# APPLICATION

PERCOLATION TESTING

HOWARD COUNTY HEALTH DEPARTMENT  
BUREAU OF ENVIRONMENTAL HEALTH  
P.O. BOX 476 ELLICOTT CITY, MARYLAND 21043  
TELEPHONE: 461-9933

SUBDIVISION Burleigh Manor Section 2 LOT NO. 28 708

# LOT 29

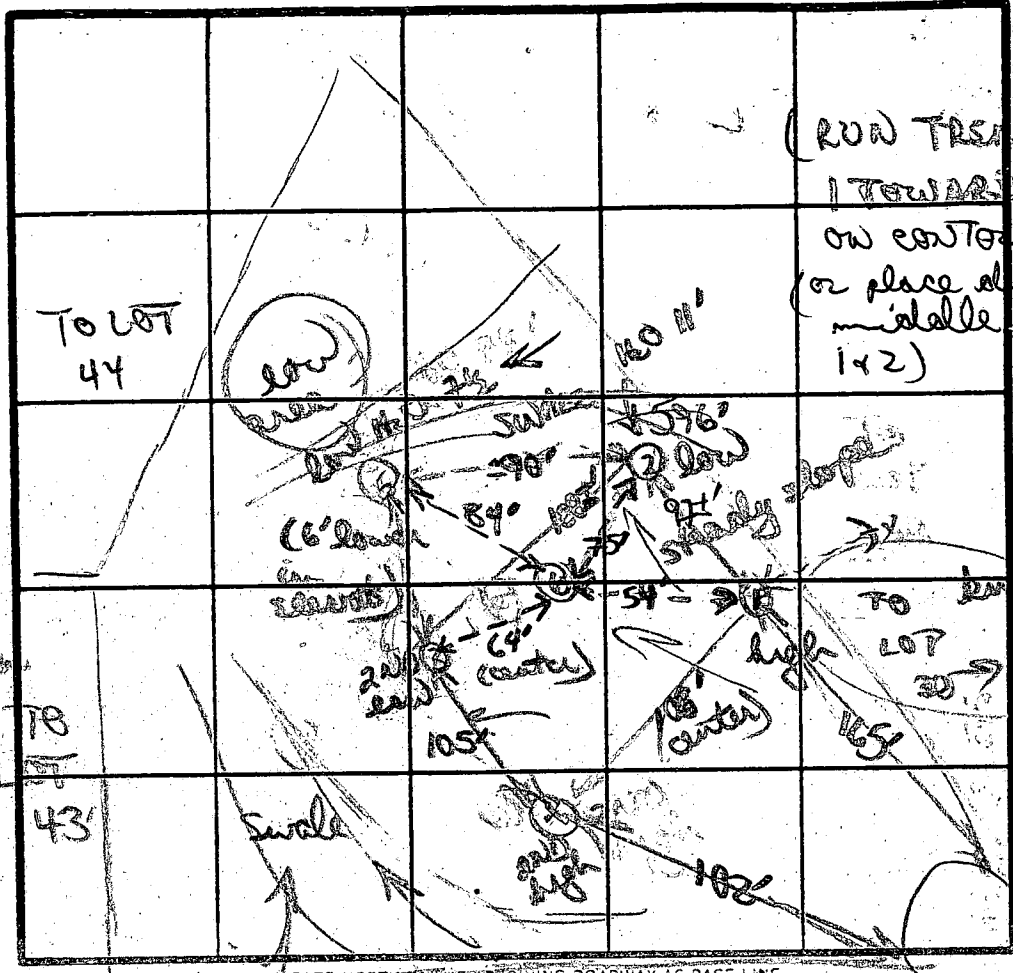
(RUN TRENCHES TOWARDS 2 ON contour) (or place abut box in middle & run towards 1 & 2)

LOT LINE WILL NEED ADJUSTMENT TO GET WELL SITE

REMARKS: adjusted perc uphill due to H.O. This along w/ close proximity of lot 30 perc requires lot line adjust & probably lot 30 perc adjust to get well site

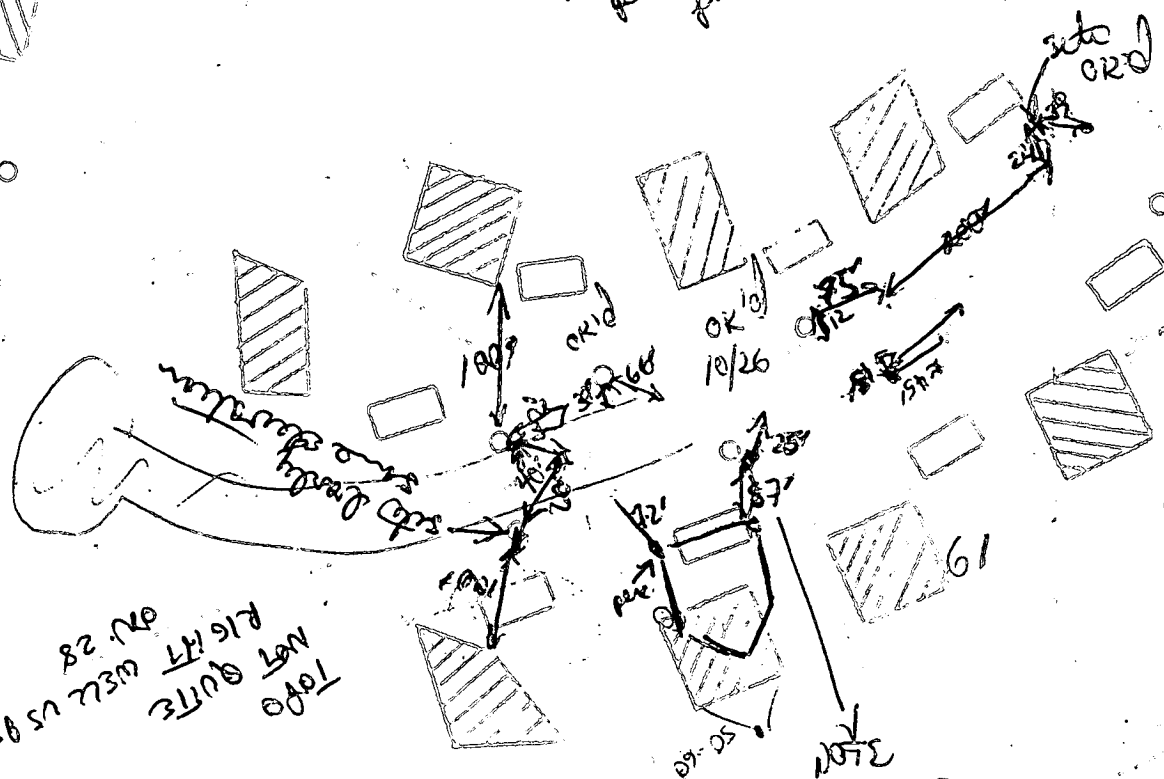
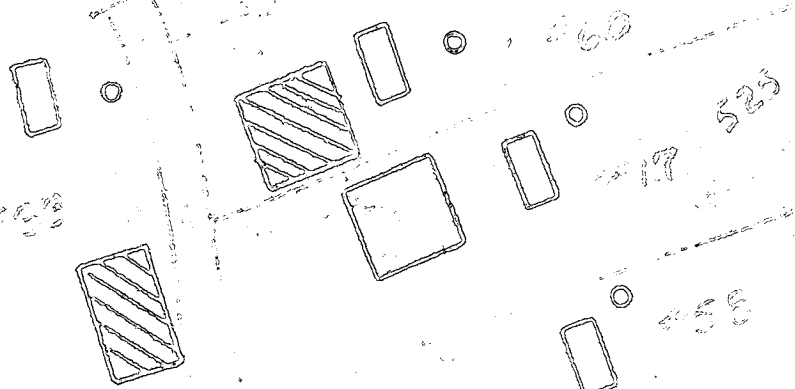
has adjusted  
perc field  
further back

TOPO  
NOT QUITE  
RIGHT WITH US SPEC  
ON 28

NOTE  
DISTANCE  
TO ACTUAL  
CLOSEST HERE  
ONLY 87', but  
perc field  
has approved  
adjusted  
perc back
